Re: Goose Haven Reservoir M-2010-071 Response to Adequacy #2
Brock,

I have provided responses to the outstanding items from your Adequacy Review 3 letter dated Oct 26, 2022.

Drawing Number:
B-1

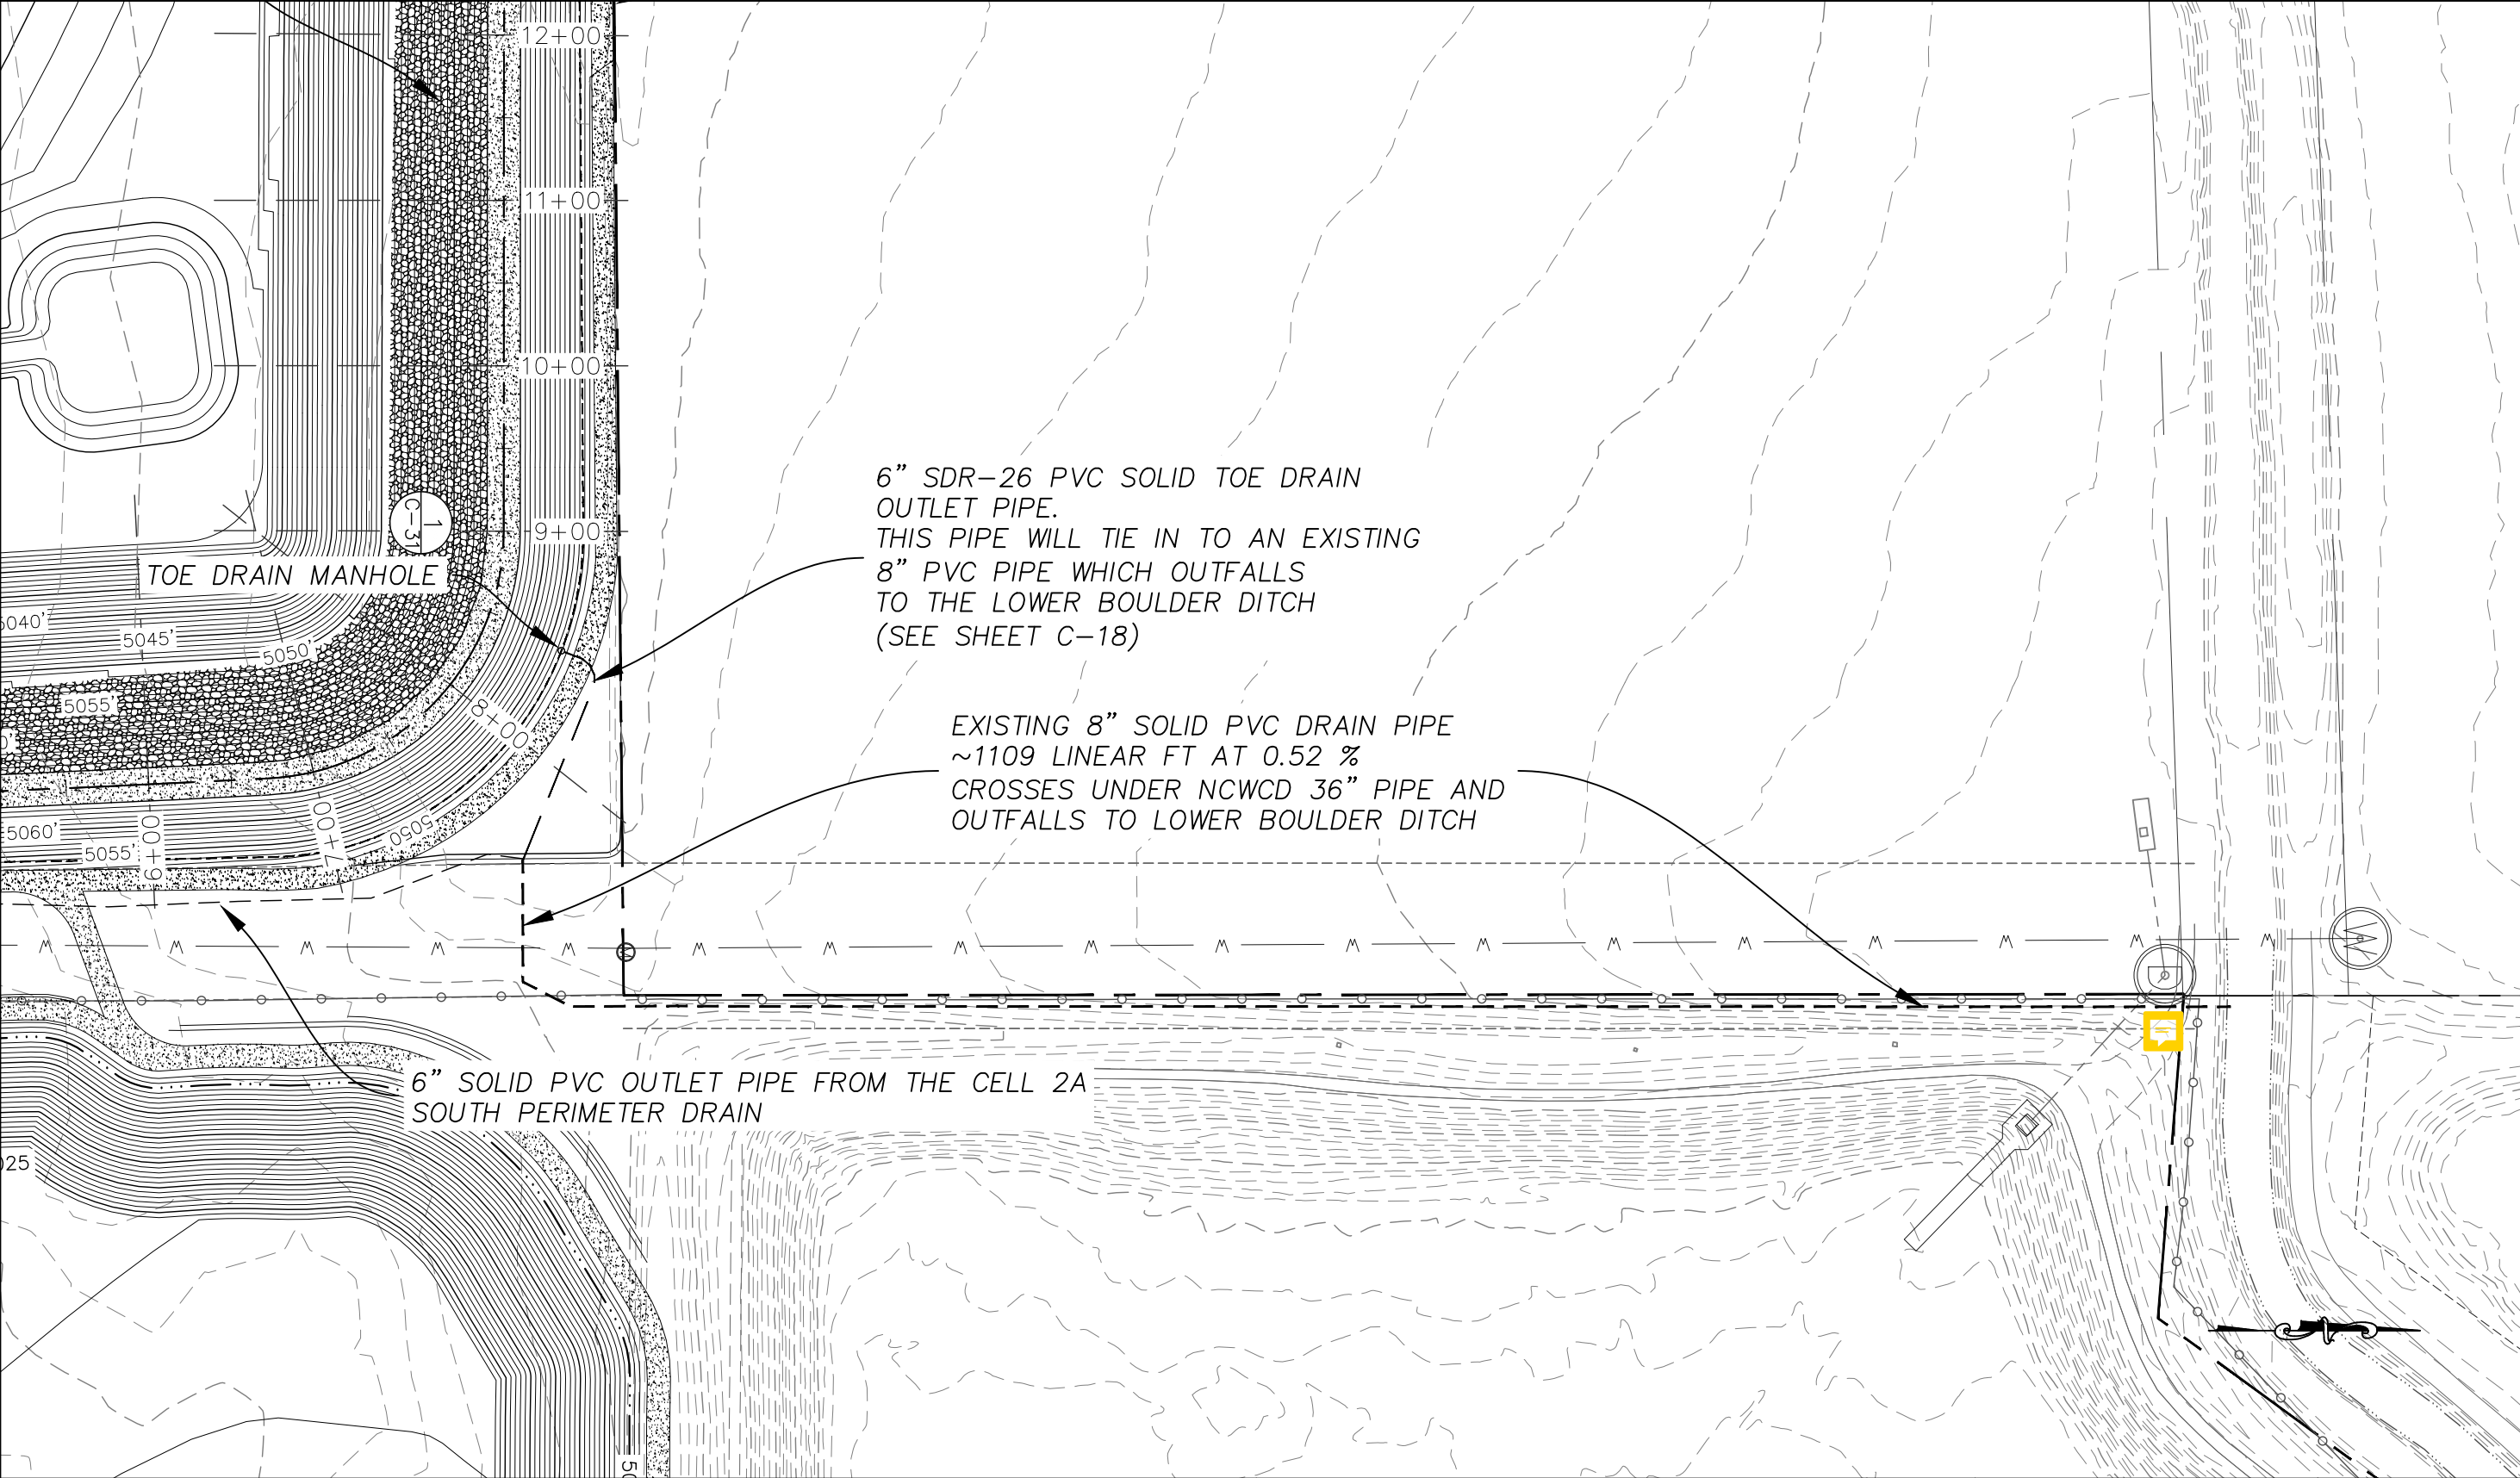
- a) In the adequacy response to Item #4, the applicant states that post-mining stormwater flows from the site will not exceed pre-mining flows. (The Division understands this statement to be relevant to the swale at the northwest corner of the site.) The applicant should provide proof that flow is less than or equal to pre-disturbance flow in the form of a hydrology model or other type of hydrologic analysis.

We request the DRMS consider the following other type of other hydrologic analysis;

A Hydrologic analysis was previously submitted in the "Goose Haven Hydrology Report" by Merrick April 30, 2009. In that report the offsite contributions to the Cell 2A area were modeled and all of the drainage sub basins upstream of the Cell 2A area were considered. I have attached sheet B-1 from this study for reference. The drainage plan only routes offsite drainage around the proposed reservoir sites in an extremely low gradient grass lined swale. The 2 new reservoirs Cells 2 & 2A effectively remove a combined area of 70 acres that would have historically contributed to the onsite runoff and drained onto the Boulder County property north of Cell 2A. The pre-mining (or relative historical) stormwater runoff including the reservoir sites was not modeled, based on the idea that the reservoirs will

remove significant runoff acreage from the drainage area. That combined with the knowledge that no increase in impervious ground will occur as the result of this project informed the drainage engineer that that a detailed “historical” runoff model in this case would not be relevant.

**FIGURE HS-1A
OUTLET DRAIN PIPE**

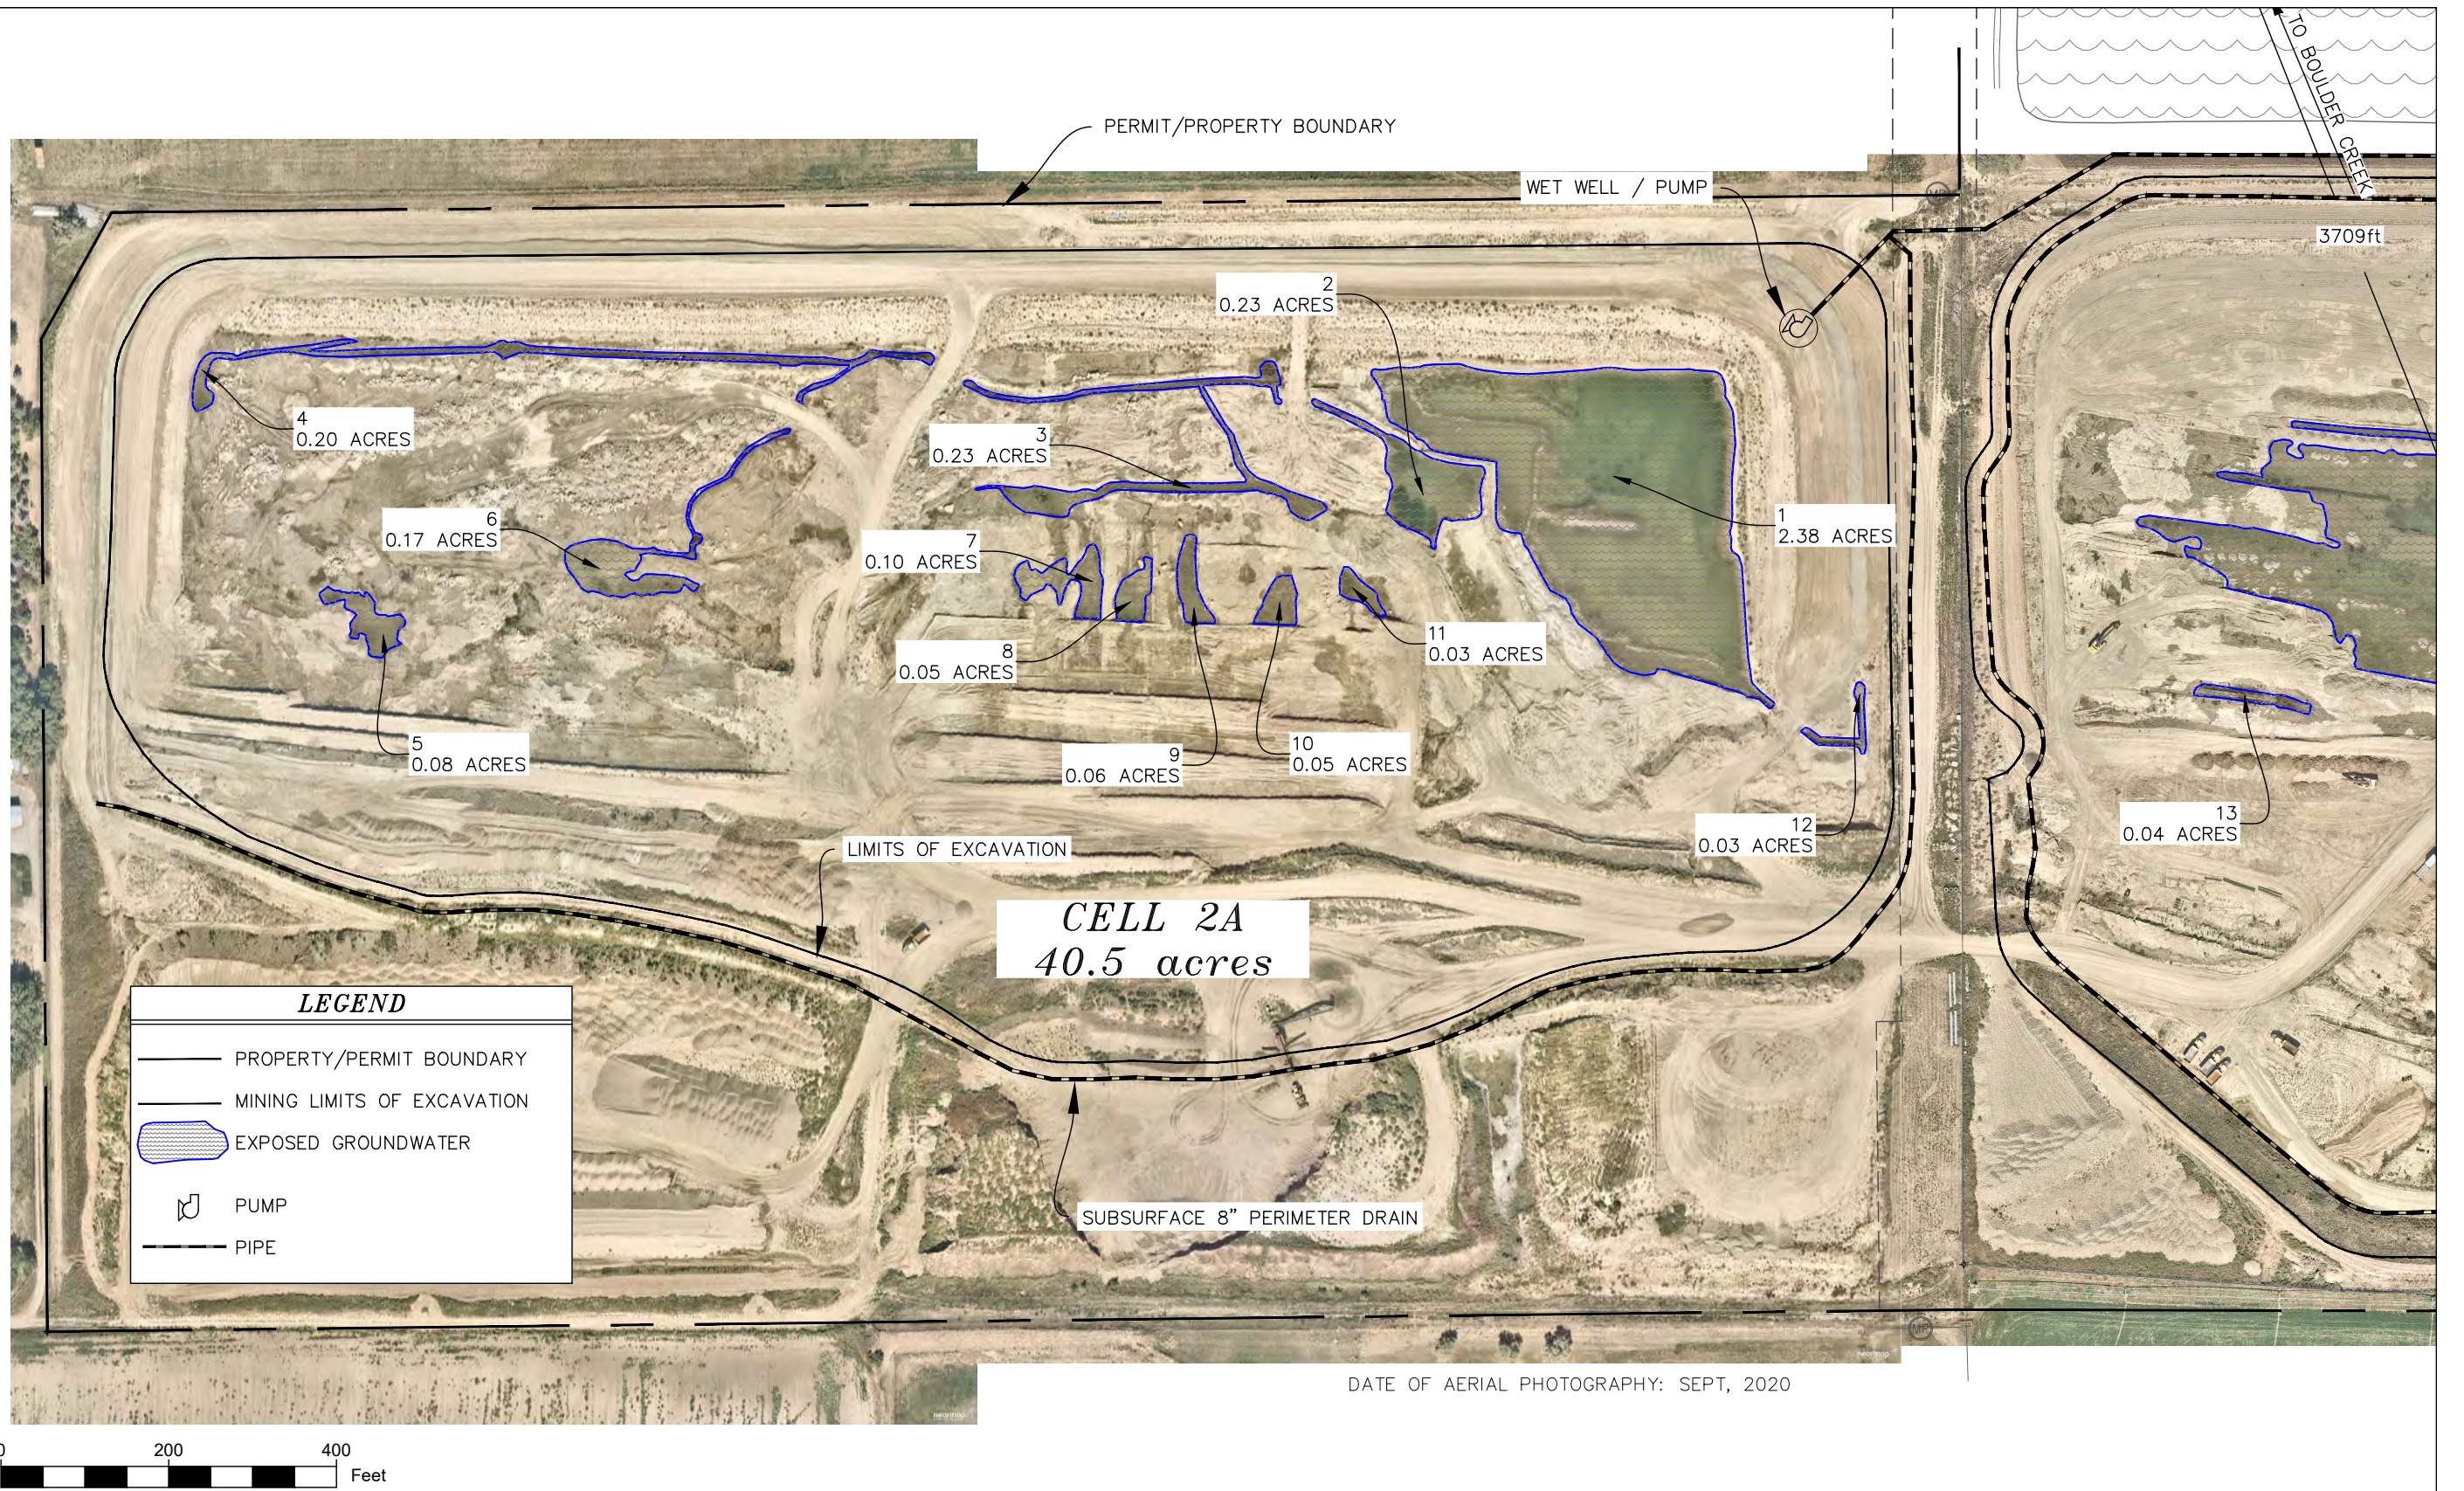
3. During the pre-operation inspection the Operators representative stated the outfall is pumped to discharge to the ditch. Please explain if the representative meant the lined ditch immediately north of the site or the Boulder and Weld County ditch located along Boulder Creek approximately 0.5 miles north of the site. Please provide a map that shows the alignment of the discharge piping.

A map showing the alignment which discharges to the Lower Boulder Ditch. Before development of the site, this pipe was connected to a series of clay pipe field drains and a small pond in the NE corner of the Cell 2A site.

By routing flow from the south perimeter drain and the dam toe drain through this pipe, the City will be maintaining the historical hydrologic balance of the area.
